IEC 60079-25
Edition 1.0 2003-08

Part 25: Intrinsically safe electrical systems

INTERPRETATION SHEET 1

Figure C.7e) – Diagram for 5 mH

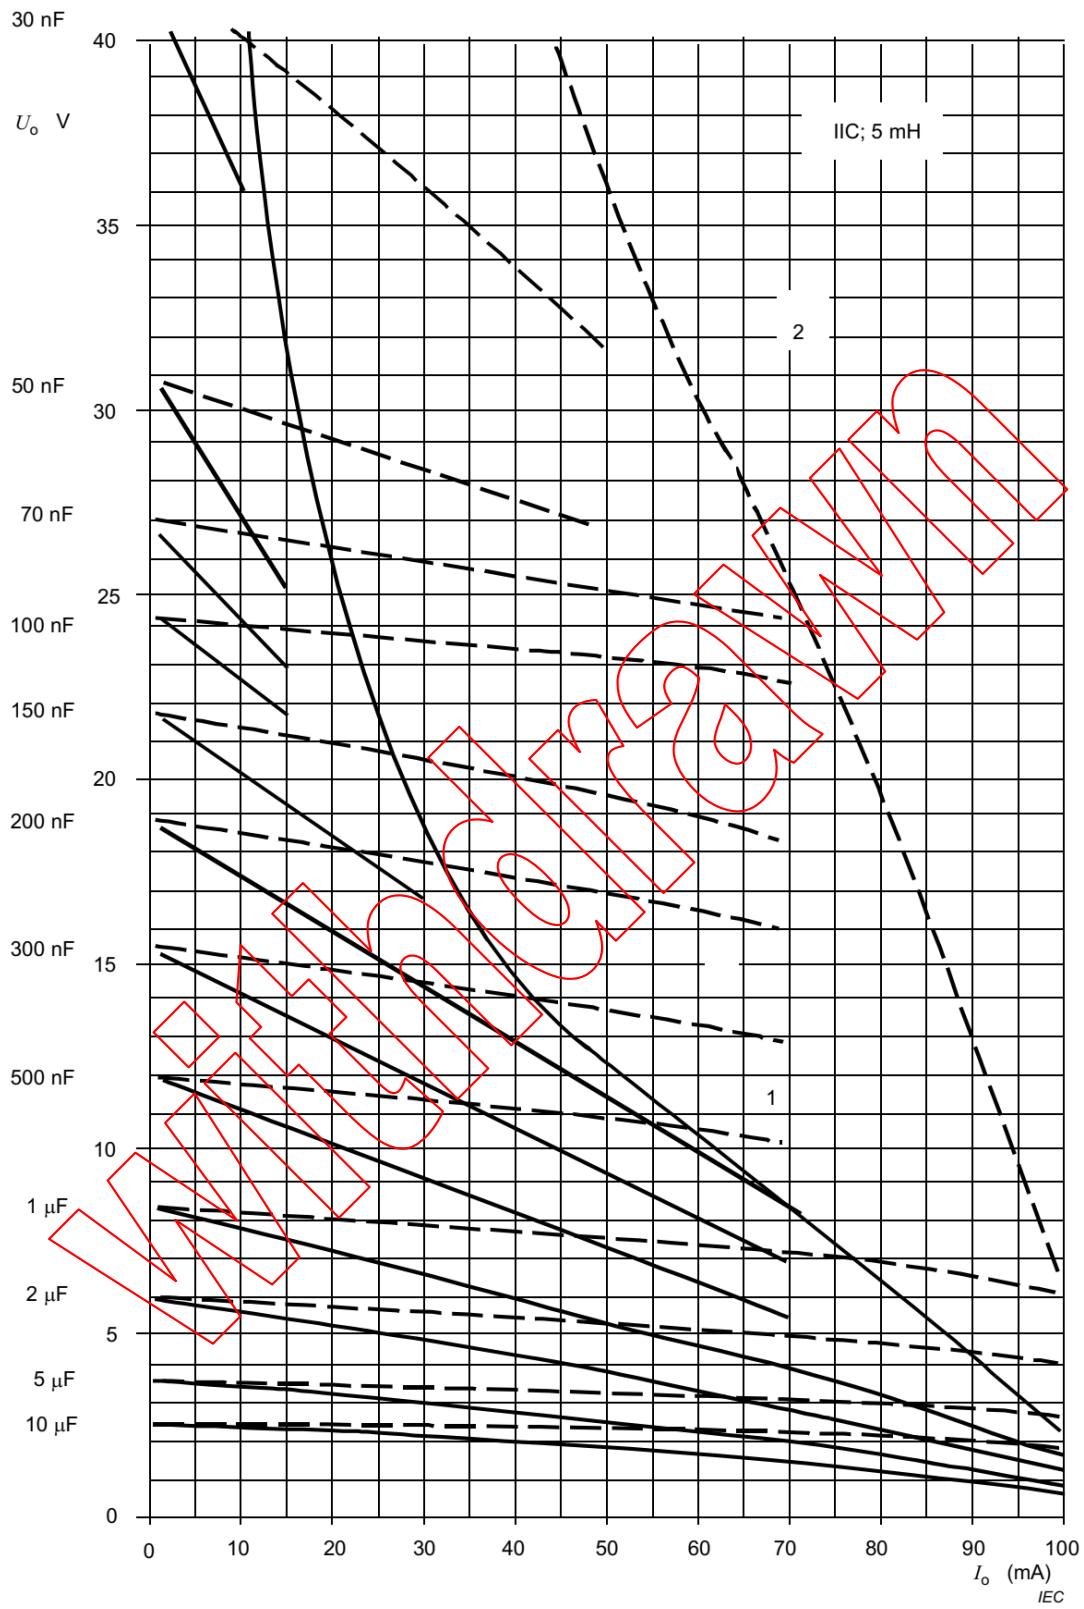
The x-axis of Figure C.7e) is incorrectly numbered. The x-axis should be numbered 0 to 100, but instead is numbered 0 to 120, and the index for 50 has been omitted.

The following new figure replaces existing Figure C.7e) in IEC 60079-25:2003.
